Analysis of the Stream Restoration Design of Donaldson Run Tributary B in Arlington, VA

Dr. John Field

December 2020

Figure 6. A portion of Drawing C-1 (VHB, 2019) showing proposed uniform meanders. Right and left bank are based on a downstream view with flow from left to right. The area highlighted by the red box is discussed in text.

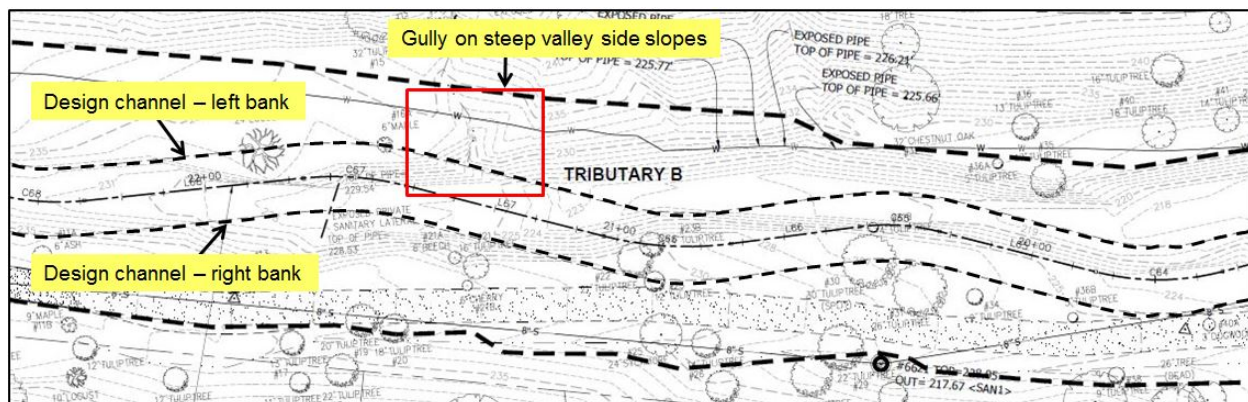
Implementing the design channel as presented in VHB (2019) will necessitate a massive and costly earth-moving operation that will result in a significant realignment and alteration of the current channel and adjacent portions of the valley bottom. Numerous uniformly shaped meanders will be constructed in the upper portion of Tributary B (Figure 6). The justification for this is based on the fact that “alluvial” streams (those streams that are capable of self-forming a channel across a floodplain) tend to form meanders to achieve an equilibrium condition. However, as stated above, Tributary B never had a floodplain and was never able to self-form a channel prior to urbanization. As a consequence, the design channel does not truly represent the natural stable configuration for this setting and, as a consequence, instabilities will likely result.

The red box in Figure 6 highlights one of many locations where the design channel approaches the steep valley side slopes due to the lateral space needed to create the proposed meandering planform. At the highlighted location, a steep gully on the side slope will drain directly into the proposed channel and, as a result, could rapidly deposit large amounts of sediment. Such rapid inputs of sediment are unlikely along alluvial rivers that flow across a low floodplain, so the design (that essentially assumes Tributary B is alluvial) does not plan for such “outside” inputs of sediment and the proposed channel will be destabilized as a result.

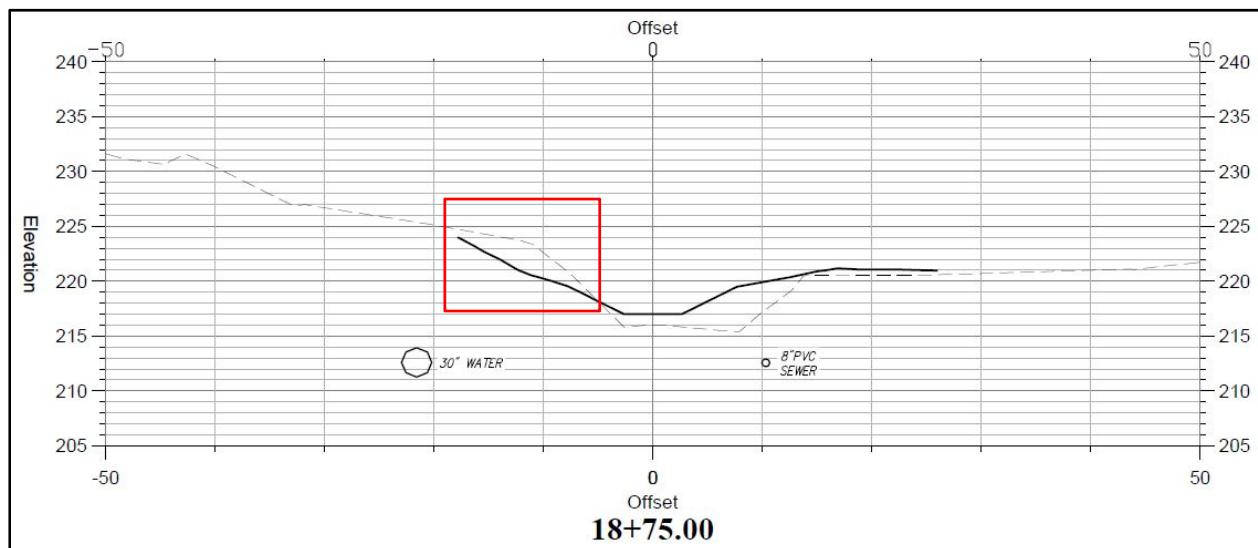
Figure 7 is a cross section showing one location where the design channel will actually be excavated into the base of the steep valley side slope. This could destabilize the slope and trigger a landslide – a threat that will increase over time as flow in the design channel continues to impinge on and eat away at the slope. No evidence is provided in the design package (VHB, 2019) that documents a geotechnical analysis has been completed to determine the risk of such a landslide. The potential consequences of a landslide (or rapid inputs of sediment from the gully highlighted in Figure 6) would be to completely infill the design channel, allowing the flow to escape the design channel, reform a new channel elsewhere on the valley bottom, and cause the abandonment of the entire design channel downstream. This begs the question “Why does the design propose to form meanders in the upper confined section of Tributary B where no meanders ever existed before?” and also demonstrates that the primary project objective to stabilize the stream will not be achieved.

Figure 8. The lower sinuosity design channel proposes to cutoff the existing high sinuosity meander (centerline shown with dashed red line). (From VHB, 2019, Drawing C-2)

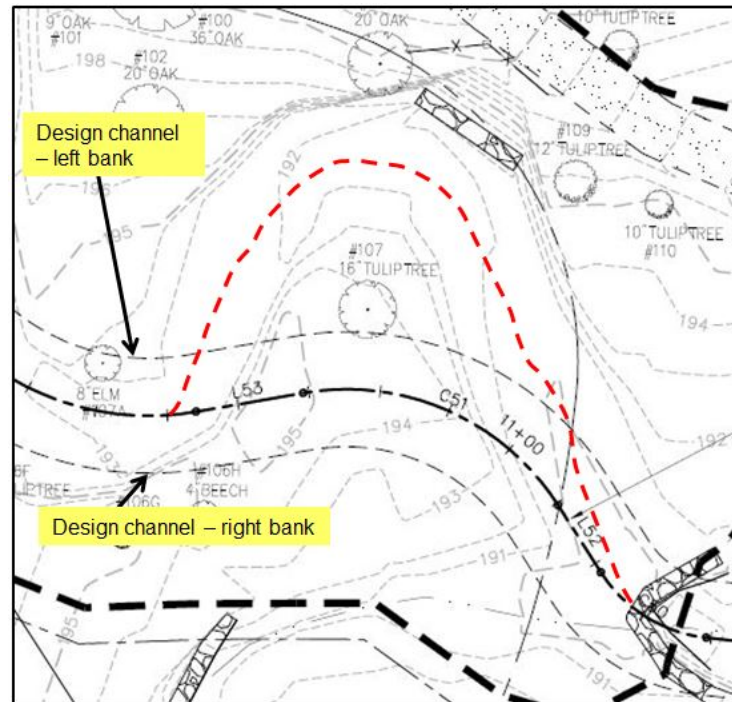
By maintaining essentially the same uniform meander shape throughout the project, problems at the downstream unconfined end of the project are also possible. The proposed design will cutoff one of the existing highly sinuous meanders (Figure 8) that, as described in Section 3.0 above, is the natural stable meander form for this setting. The proposed less sinuous meander, then, will be an unstable feature that will eventually be undone over time as the more sinuous meander

dimension is reestablished. This process would most likely be initiated when backwatering caused by high water in Tributary A leads to deposition and infilling of the design channel.

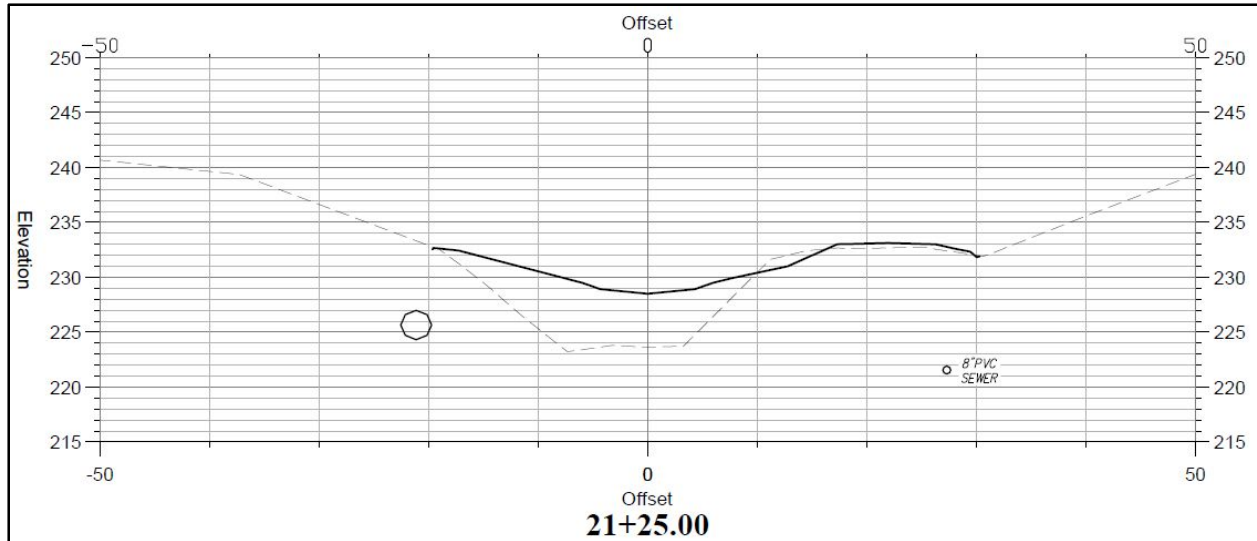
VHB's (2019) restoration design proposes to fill, at least partially, the existing incised channel with what will presumably be a mixture of sand, silt, and clay (Figure 9). The amount of fill to be added is generally greater in the upper part of the proposed project with much less needed downstream where the existing stream is less incised. However, some fill is proposed for nearly the entire project's length. The cross section in Figure 9 is typical for the upper portion of the project with the depth of fill ranging from 5 to 7 feet depending on the position of the "thalweg" (i.e., deepest portion) and banks of the proposed channel. No details are provided in the design plans regarding the total volume, character, or origin of the fill to be used. The design justification for filling the existing channel with more than a thousand cubic yards of presumably imported fill is twofold: 1) to elevate the stream bed so that flows can more easily escape the channel and spread over the flat valley bottom in order to limit the stream power exerted in the design channel; and 2) to narrow the channel to approximate the expected width of an equilibrium channel in an undisturbed setting (with an adjustment factor added in recognition of urbanization as described in VHB, 2019, Drawing D-1).

Figure 10. Cross section showing particularly well how fill placed in existing channel (dashed line) will create a narrower design channel (solid line) through most of the project's length. (From VHB, 2019, Drawing C-12)

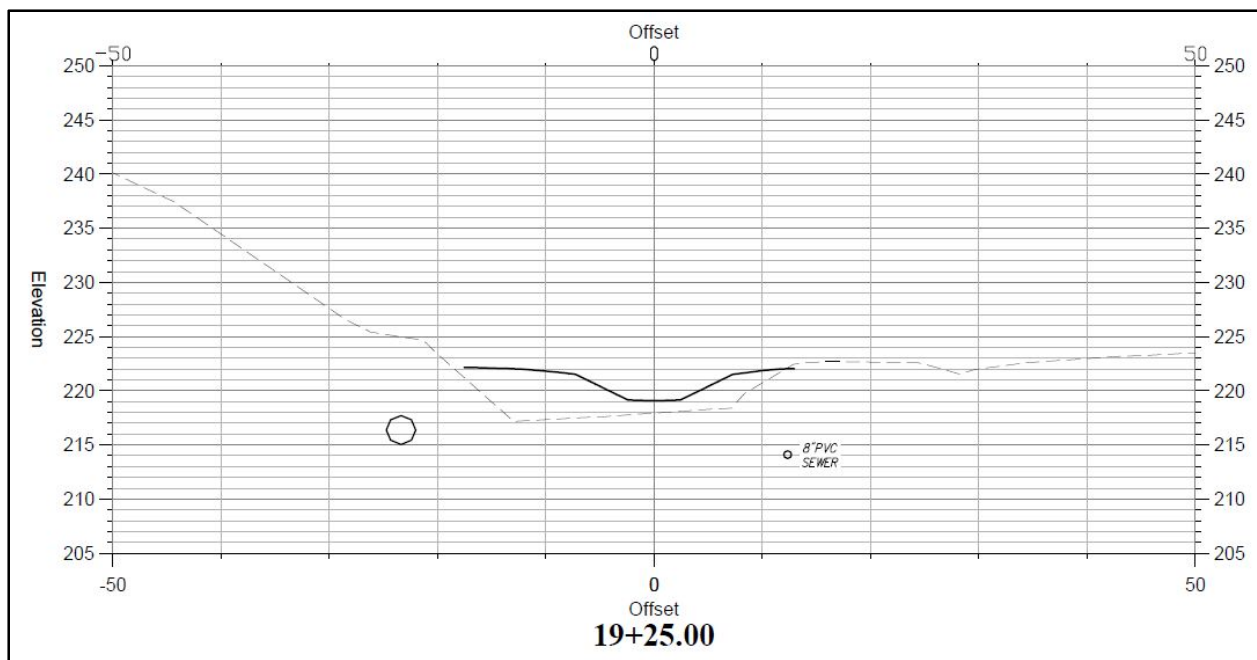
Elevating the stream bed by adding fill in the channel increases the stream's gradient and, in turn, increases the stream's capacity to carry sediment. The stream's length in the project area is being shortened from 1,404 feet to 1,331 feet (VHB, 2019, Drawing C-3) due to planform changes like that shown in Figure 8, leading to additional slope increases. (Perhaps imperceptible to the human eye, streams trending towards an equilibrium condition are sensitive to even minor slope changes.) The fill is also being added to the existing channel to narrow its width (Figure 10). Squeezing the flow through a narrower channel, like putting a finger over the end of a garden hose, will further increase the flow's velocity and ability to carry sediment.

What may appear as only subtle changes resulting from adding fill to the existing channel could actually cause significant problems. Please note that elevating the stream bottom and narrowing the channel by adding fill stands in stark contrast to the stream's natural channel response of incision and widening that has been ongoing for several decades. As described above in Section 3.0, this has been occurring to achieve a new equilibrium condition in balance with the urbanized watershed. Why, then, is the sediment that has taken decades to wash downstream now being replaced with imported fill? The long-term fate of the fill will invariably be similar to previous soils eroded away given that implementation of the project will have no effect on the high volume of runoff emanating from the urbanized watershed. Simply changing the form (i.e., width, slope, and sinuosity) of the channel as proposed in the restoration design does not change the process at the root of the problem.

Figure 11. Cross section showing existing channel (dashed line) filled in to accommodate design channel (solid line), but leaving a low spot on the valley bottom (highlighted by red arrow) beyond the limit of disturbance. (From VHB, 2019, Drawing C-11)

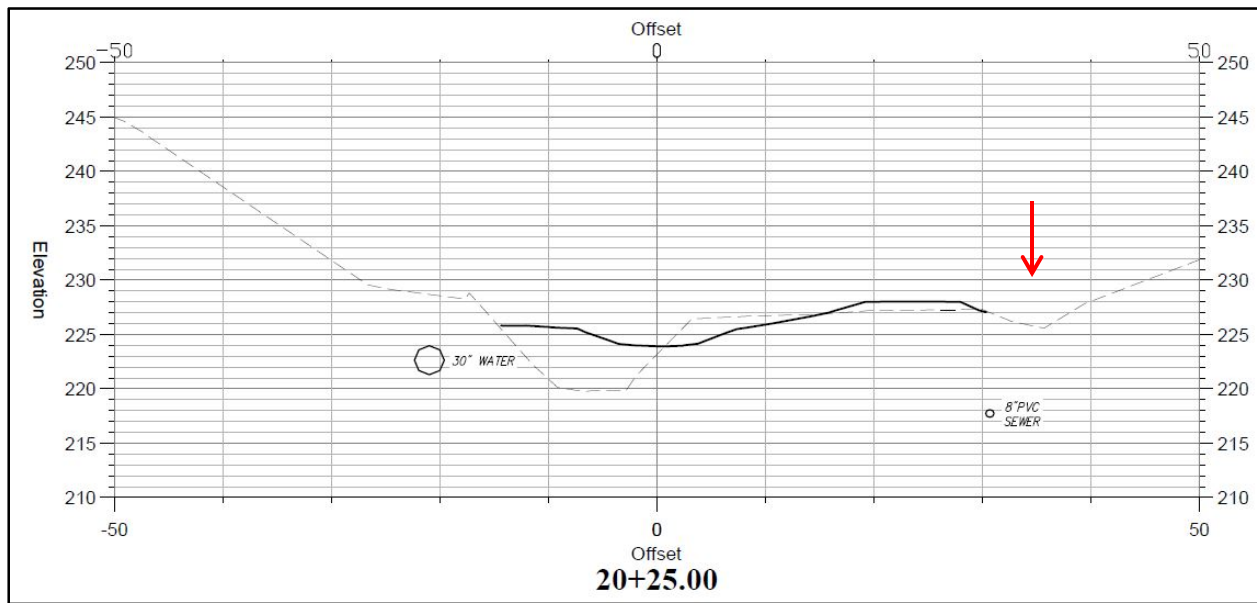
The increased flooding of the valley bottom surface could have even more serious consequences as well. Where the design channel extends beyond the limits of the existing channel, the existing channel will be filled to the level of the valley bottom, but existing low spots on the valley bottom beyond the limits of disturbance will remain (such as the drainage swale along the walking path) (Figure 11). These low spots near the downstream end of the project are at times even lower than the bottom of the design channel itself (see VHB, 2019, Drawing C-16, Section 11+25.00).

The overbank flow emanating from the design channel will preferentially concentrate in these low spots on the valley bottom and could initiate channel incision to a depth lower than the design channel itself. In such an event, the design channel would be abandoned and the entire flow of the stream diverted to the newly incised channel. The potential damages from a new channel being carved on the valley bottom are significant as most of the existing low spots on the valley bottom are immediately adjacent to the sewer line. While the likelihood of such an event is low, dismissing a low risk event would be unwise given the potential high cost of repairs. By adding fill in the existing channel but leaving low spots on the valley bottom, the project could fail to meet its primary objective of stabilizing the stream and the project's explicit goal to protect adjacent infrastructure.

Figure 12. Portion of typical cross section showing 18-inch rock bed layer to be added to design channel along the length of the restoration project (From VHB, 2019, Drawing C-6)

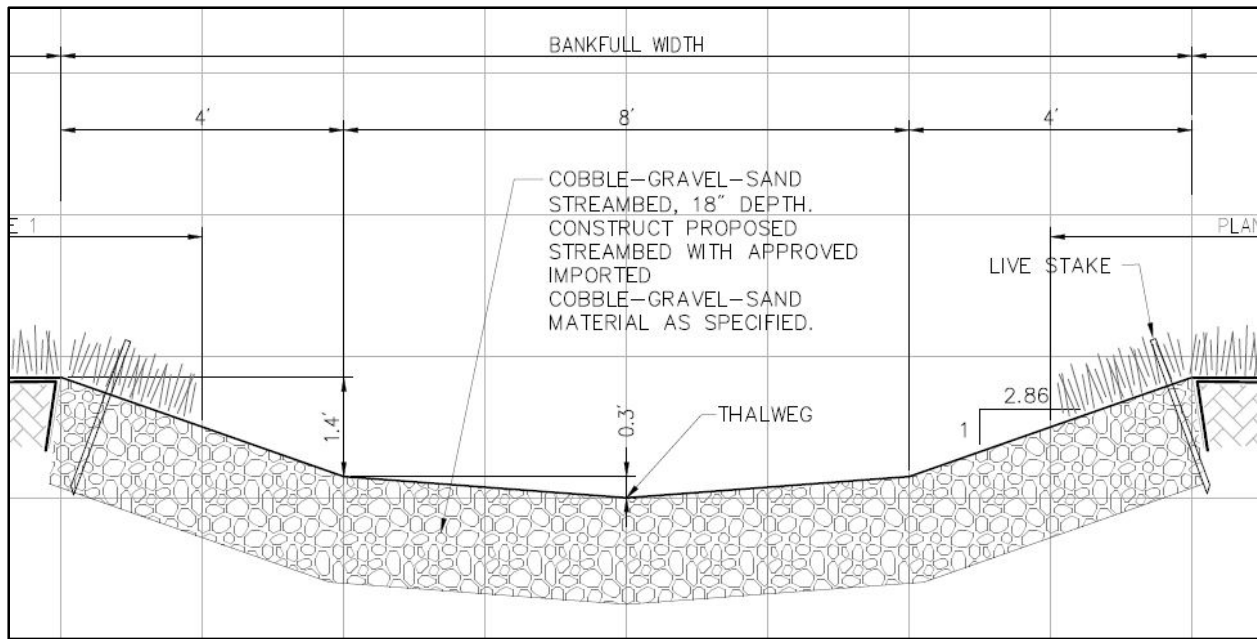
Large rock is to be placed in the design channel in the form of an 18-inch thick bed layer across the entire channel bottom (and banks) throughout the length of the project (Figure 12). The "D₈₄" rock size to be used will have a diameter of 15 inches (i.e., a small boulder), which means that 84 percent of the rock will be smaller (including at least 10 percent sand) and 16 percent larger than that value (VHB, 2019, Drawing D-1). Much larger more rectangular boulders (with an intermediate axis diameter up to 5 feet) will be used to build a variety of step-like rock structures (VHB, 2019, Drawing C-4 and C-5) throughout the project's length (Figure 13). The justification for the coarse bed layer is to keep the stream bed and banks from eroding given that the sediment supply from the urbanized watershed is lower than in a more natural environment. The numerous boulder step structures are justified as "grade controls" (i.e., to prevent downcutting of the channel) and habitat features.

The rock size used in the 18-inch thick bed layer has been carefully selected to remain immobile up to a 10-year flood event (VHB, 2019, Drawing D-1). What will happen, however, during an even larger flood when the bed layer is able to move? With only finer-grained fill underneath the coarse bed layer (see Section 4.2 above), the implication, perhaps expectation, is that the design channel could be enlarged through bed and bank erosion with the currently existing gully

Figure 12. Portion of design plan showing several of the boulder step structures to be built across the proposed channel along its entire length. (From VHB, 2019, Drawing C-7)

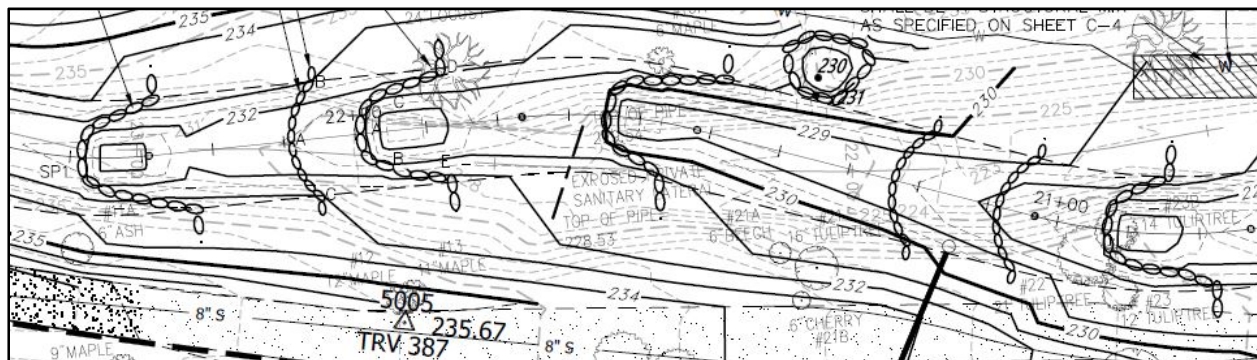
The large rock, although not explicitly stated, is essentially being used to armor or lock the proposed design channel in place in direct contradiction to the basic tenets of Natural Channel Design (Rosgen, 2011). As a result, the use of large rock in the design is a tacit acknowledgement that the proposed project cannot function as a geomorphically “stable” channel (see Section 2.0 above). By creating a static rather than a stable channel with the freedom to adjust its position over time, several potential problems are likely to arise if the project is implemented as designed.

The use of the large boulders to form the rock step structures also presents problems. Boulder steps are natural features found on confined and steep mountain streams. While the upper portion of the restoration reach on Donaldson Run Tributary B is confined and fairly steep, the soils are largely composed of fine-grained material with no boulders occurring naturally. When stream flows encounter a contact between large immobile boulders and fine erodible sediment, the stream will preferentially and aggressively scour the fine sediments on the bed or banks of the channel. Since the boulder steps will be set below the coarse bed layer (VHB, 2019, Drawing C-5), undermining of the structures seems less likely than the “outflanking” of the structures (i.e., lateral erosion around the steps) due to bank erosion. Similar outflanking of boulder structures occurred as a result of bank erosion along the design channel constructed as part of the nearby Donaldson Run Tributary A restoration completed in 2006 (Figure 13).
